SECTION 73

MINOR PLANNING AMENDMENTS TO APPROVED CONSENT

APPLICATION REF: 4/21/2242/OL1

FULL RENOVATION OF EXISTING No 11 TERRACE HOUSES

Elevation 6 (house 6 side elevation)

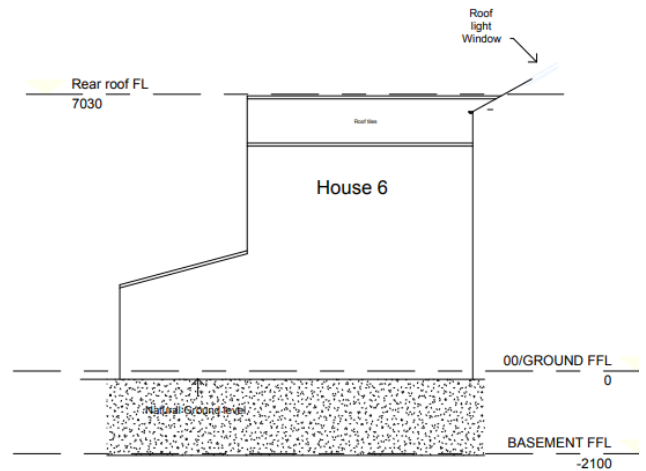
From the rear of house, no 6, a modern dry verge has been applied to the verge of the roof which is completely out of character. See below.

The roof is covered with a modern cement tile with a dry verge detail.

The current roof pitch is 15 degrees.

The proposal is to replace the rotten joists with new joists as recommended by the structural engineer as 45 x 95 C16 GR multi rafters.

The proposal is then to replace the roof itself as the detail attached, with a roof tile that is warrantied at 15 degrees. The proposal is then to apply a traditional wet verge.

Elevation 7 (house 7 side elevation)

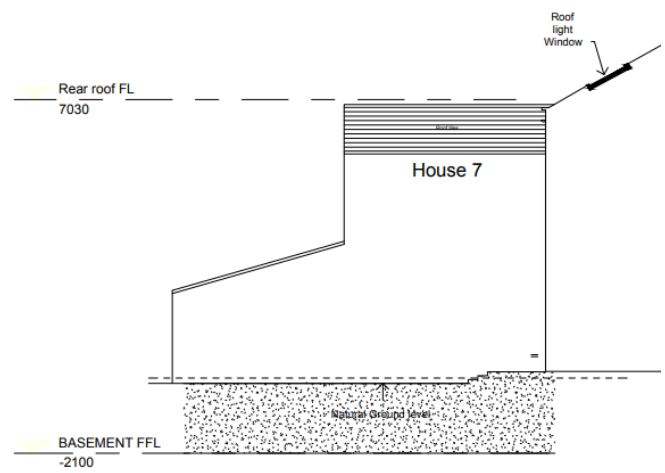
From the rear of house, no 7, a natural slate roof is the finish, however at 20 degrees – the absolute MINIMUM roof pitch, a slate roof is feasible, however the construction of this slate roof is not in accordance with the Building Regulations as the British Standards Ref: BS 5534:2014 which require slates to be a min size of 500 x 225 with a 135mm head lap, hence why the roof is leaking and again the joists suffering considerable damage.

For the reasons outlined above the proposal is then to replace the roof itself as the detail attached with a roof tile that is warranted at 20 degrees. The proposal is then to apply a traditional wet verge.

Elevation 8a (house 8 side elevation)

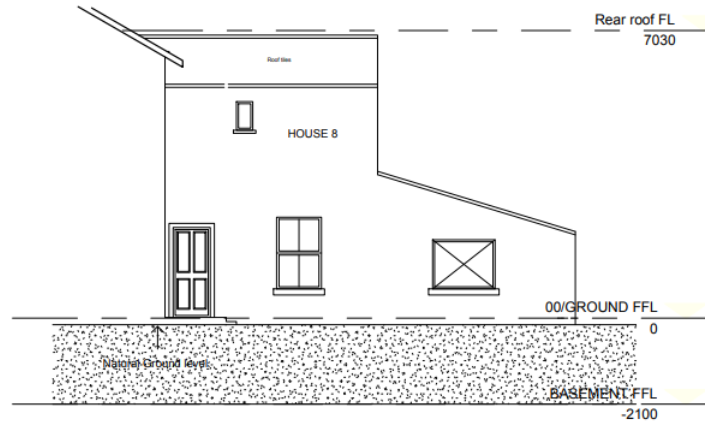
From the rear of house, no 8, a natural slate roof is the approved finish, at 20 degrees. This is the absolute MINIMUM roof pitch where a slate roof is feasible, as acknowledged by Building Regulations - British Standards Ref: BS 5534:2014. However, the roof itself does not accord with the Building Regulations, as the same British Standard require slates to then be a min size of 500 x 225 with a 135mm head lap. The low pitch along with the slate sizes, and the location of the buildings, is why the roof is leaking, leading to the considerable damage to the joists (as demonstrated by the photographs

For these reasons, the proposed amendment to the approved plans is to replace the roof itself as shown by the detail attached above, with a roof tile that is warranted at 20 degrees. The proposal is then to apply a traditional wet verge.

Elevation 9 (House 9 side elevation)

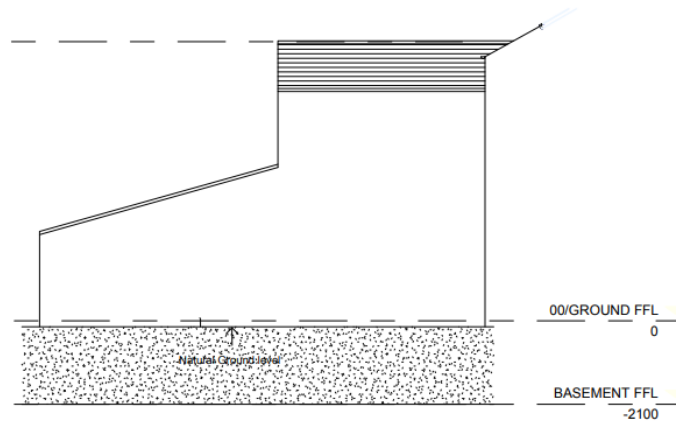
Left and below: The existing shower block ceilings and walls were concealed with moisture resistant boards. So while it was acknowledged that some minor repairs would be required, the extent of repairs required are far greater than envisaged, now that the existing finishes have been stripped out – please see the before and after photographs above and below.

Now that they have been exposed, it is clear that the original joists have been replaced in most of the roof, unfortunately with new joists that are completely inadequate for the loads involved, and will require replacement with suitable sized joists.

It is also noted that this roof comprises a modern cement tile that is to be replaced with slate, so as to be consistent with the other rear extensions.

The pitch to this roof is also only 17 degrees, the low pitch not only been unsuitable for purpose but also a direct contributor to the damage identified. As this is a later extension, it is proposed to raise the pitch to the minimum required level, to prevent further issues. The change would not, however, be readily apparent, if at all.

For the reasons outlined above the proposal is then to replace the roof itself as the detail attached, with a roof tile that is warranted at 20 degrees. The proposal is then to apply a traditional wet verge.

Elevation 10 (House 10 side elevation)

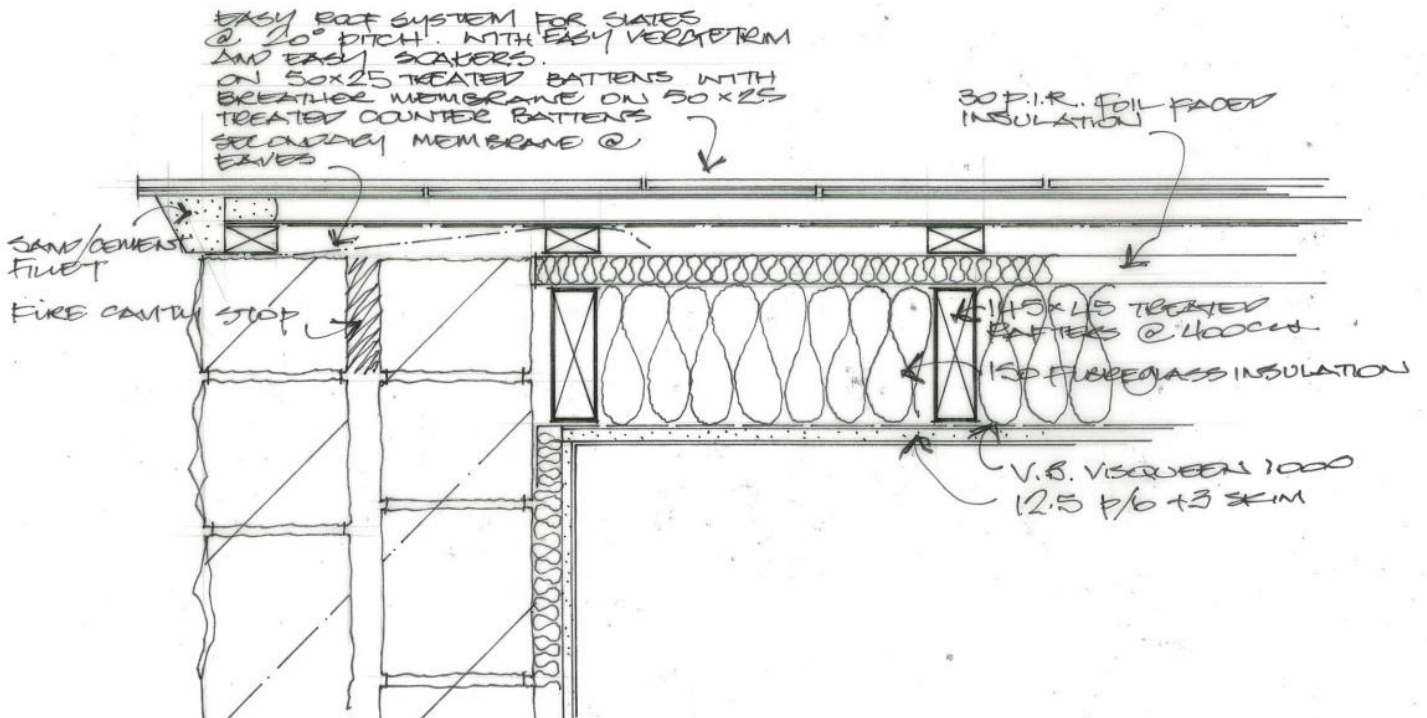
As for the other properties, once stripped out, the structure is exposed to reveal substandard rotten joists which have undergone inappropriate repairs. The joists are insufficient for the roof load and will require replacement.

From the rear of house, no 10, a natural slate roof is the finish, however at 20 degrees – the absolute MINIMUM roof pitch, a slate roof is feasible, however the construction of this slate roof is not in accordance with the Building Regulations as the British Standards Ref: BS 5534:2014 which require slates to be a min size of 500 x 225 with a 135mm head lap, hence why the roof is leaking and again the joists suffering considerable damage.

As identified previously, not only does the roof not conform with Building Regulations, but this has led to the issues identified, and the works required. In order to prevent them from reoccurring in the future, the proposal is to replace the roof itself as per our detail attached , with a roof tile that is warrantied at 20 degrees. The proposal is then to apply a traditional wet verge.

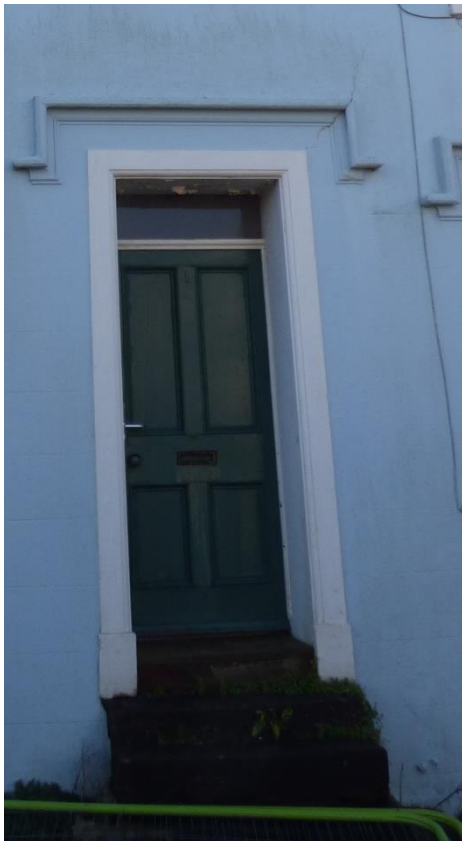
It is proposed to replace the existing letterboxes which vary in style, size and position within the doors (indicating their later insertion), with the exception of the door at House no 4 where the letterbox aperture is currently within the panel of the door – here it is proposed to locate the letterbox in the mid rail of the door.

It is proposed to provide and install new letterboxes all the properties with a new heritage style letterbox as illustrated below in antique brass:

The dimensions are 7.6cm x 33cm

The approved layout plans with areas affected by the weak floor structure highlighted in blue.

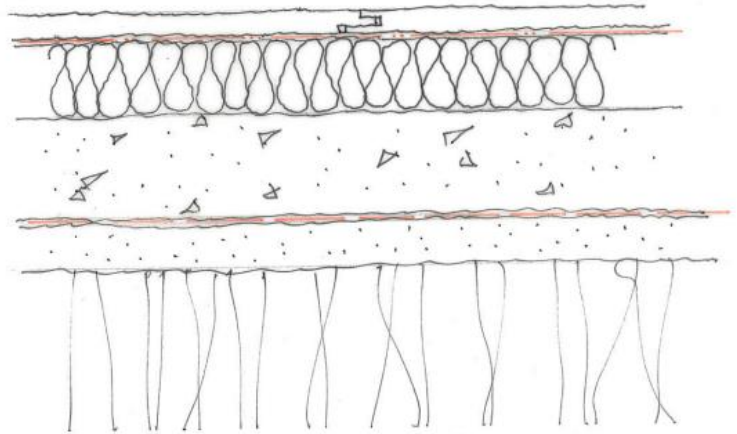
Once the existing tiled floor finishes were removed from the ground floor out rigger buildings, for properties 6,7, 8, 9 and 10 it was established that the floors were not only incredibly uneven but (following some very discrete investigation) only comprised 60mm of weak concrete laid on loose earth. Given that the extensions and concrete represent later additions, sensitive works to ensure their longevity are proposed below.

Obviously, this is not a suitable substrate for the loads which will be applied to a domestic floor, and the floor is likely to subside and break up. Our proposal is to sensitively remove the existing slabs and provide and install new floors to these areas as specified in the sketch (right).

20 SKEED BOARD SEAMED JOINTS.
ON 1000g. VISQUEEN VAPOR BARRIER
TO P.I.R. BOARD FOIL FACED.
100 CONC. SLAB.
1200g. HIGH PERFORMANCE D.P.M.
ED SAND
HARDWARE

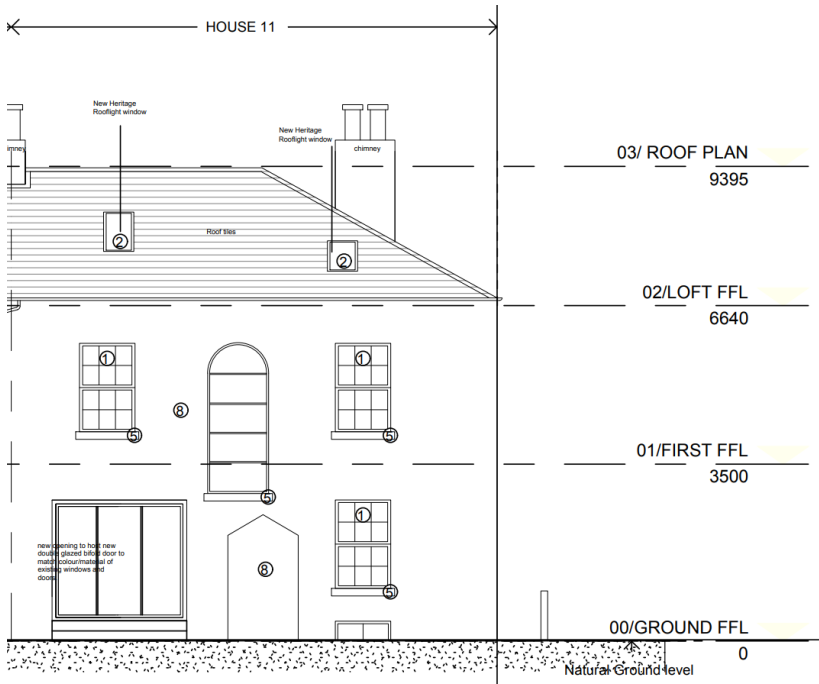
It is proposed to raise the lintels to the existing fireplaces in houses 4, 5, 6, 7, 8, and 9, to facilitate the new cookers and extract hoods to be installed, to retain the historic feature of the existing chimney, with it being reused in the slightly adjusted position. New concrete Naylor lintels will be installed to adequately support the new openings. It is proposed the height of the new openings will be 1800mm high.

The chimney (above) has been walled up, it is proposed for the opening to increase in height to 1800mm for the new stove, as all the aforementioned properties.

chimney (above) has been walled up, it is proposed for the opening to increase in height to 1800mm for the new stove, all the aforementioned properties.

New proposed French doors in lieu of bifold doors. Instead of aluminium, these proposed doors would be heritage style double glazed painted timber to match the existing windows.

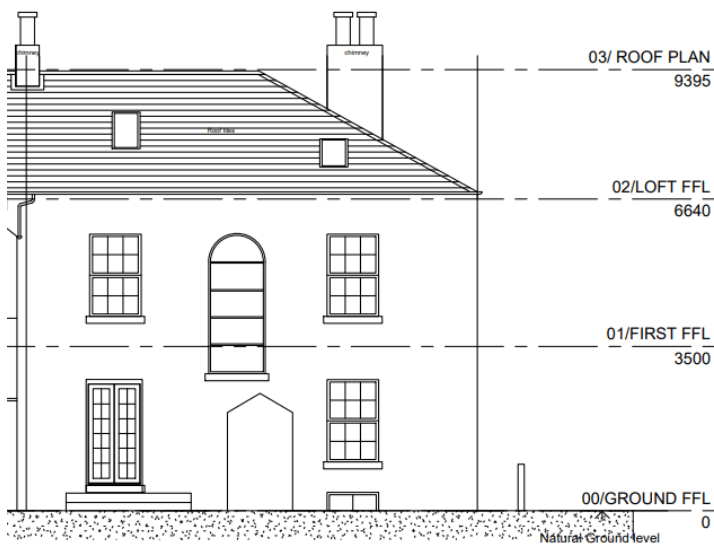
Permission was originally granted for new bi-fold doors to the rear of no 11, by replacing the original window and widening the opening, to create a new access to the garden at the rear. It is now proposed to retain the existing opening and introduce a pair of French doors instead. By doing this we retain more of the original historic fabric and more of the character of the property.

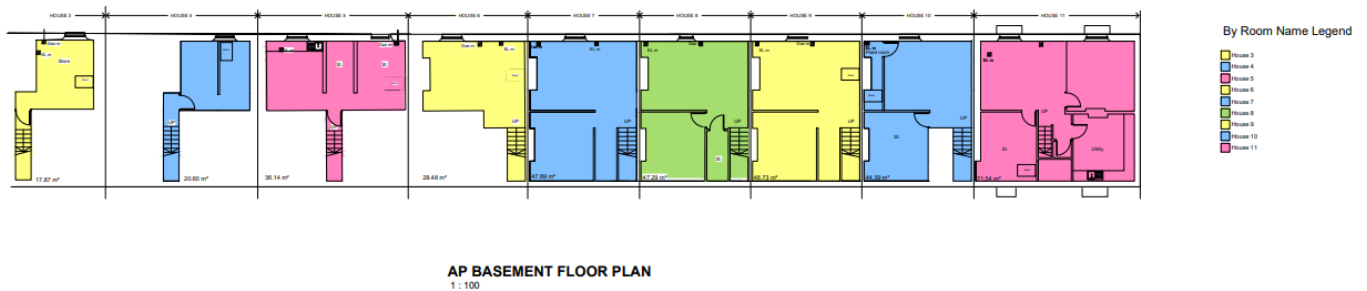
It is proposed to retain the 'blind' window to the rear, on the first floor, but instead of painting on a window – it is proposed to simply paint over it – a feature that is utilised on houses 1,4 and 5

It is also proposed to wall up the basement window and form a 'blind' window detail, as this window will be covered by patio steps from the kitchen into the garden. The window is not required internally as it is a store. The walls will be made good.

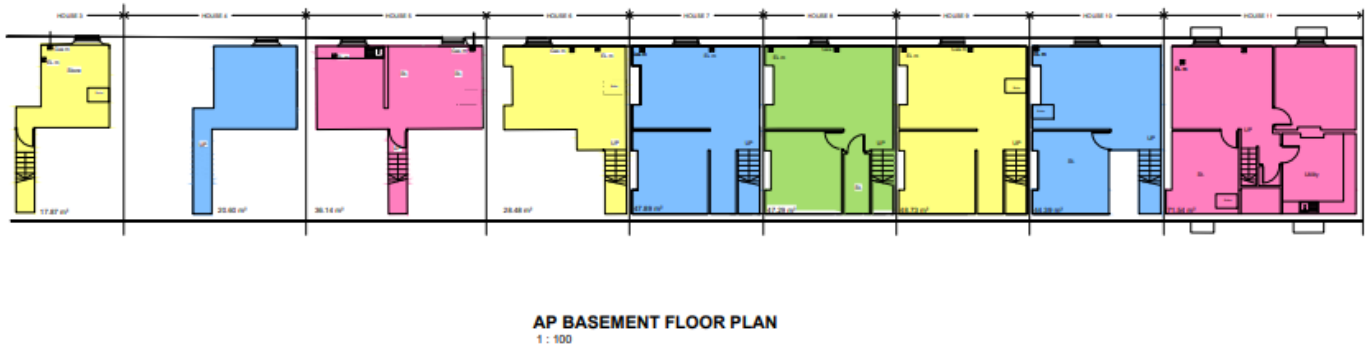
It is proposed to remove the modern stud partitions to houses 4,5 and 10 to make better use of the basements and to assist with the tanking of the basements. Below is the approved scheme.

Below is the proposed scheme with the modern walls removed to houses 4,5 and 10.

The removal of these modern stud partitions does not involve the removal of any of the original historic fabric of the building, but rather show its original dimensions. It is, therefore, trusted that the revision is considered a positive amendment.

Minor amendments to layouts.

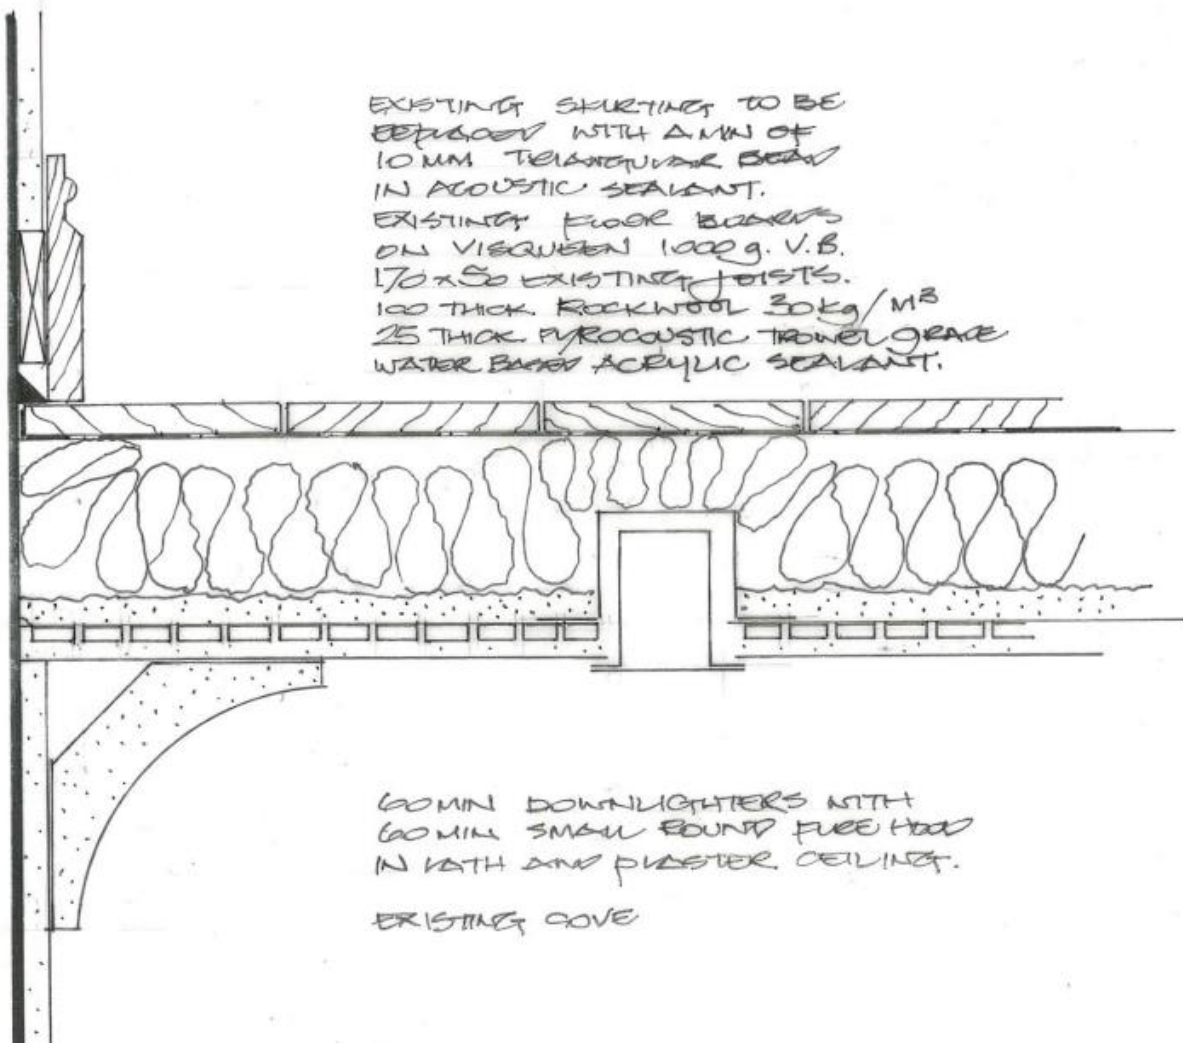
Further to detailed design of the kitchens and utility rooms, the configuration has been amended slightly from the originally approved plans. The new plans make better use of the space and also reduce the impact on the heritage asset. A full-size drawing with the revised layouts accompanies this application.

It was also assumed that house no 10 would have a chimney breast as houses 6-9, however once the false wall was removed here was no chimney breast, so the updated plans also reflect this.
